Intel Technical Advisory

TA-1042-2

The Intel® Storage Server System JBOD2224S2DP may show the incorrect system Enclosure IDs

Intel® Storage Server System JBOD2224S2DP
MM#: 927045

Figure 1. Back-side View of JBOD2224S2DP

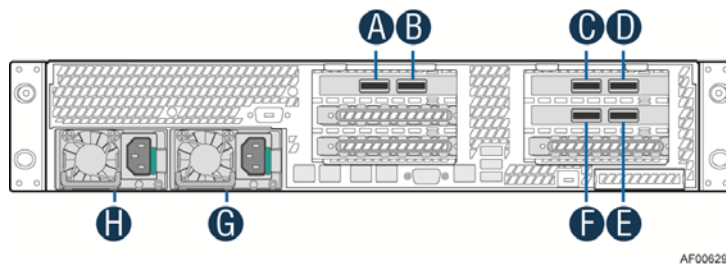
Use only the SAS SFF-8088 receptacle **A** and **B** of the JBOD2224S2DP instead of **C**, **D**, **E**, and **F** (see Figure 1). In this scenario the JBOD2224S2DP works in single-domain SAS mode, which will not be impacted by this issue.
